Landscape Plan Drawings_V1.pdf Markup Summary

Subject: Text Box Page Label: [1] 1 LS01 Author: Rob Stauffacher Date: 6/27/2022 9:34:29 PM Status: Color: Color: Color: Layer: Space:

HIGHWAY 24 & MERIDIAN ROAD SITE DEVELOPMENT PLAN

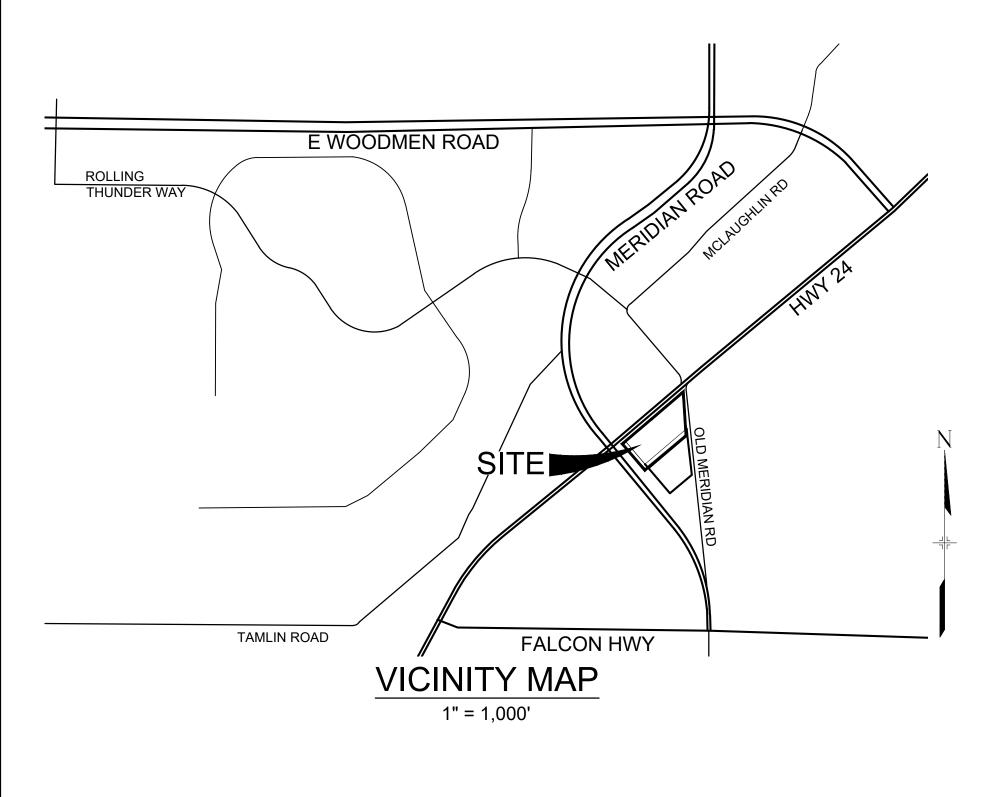
Include owner and planner/plan preparer email addressees.

nclude Signature block for the Planning and Community evelopment Director a minimum of 1 nch by 2 inch.
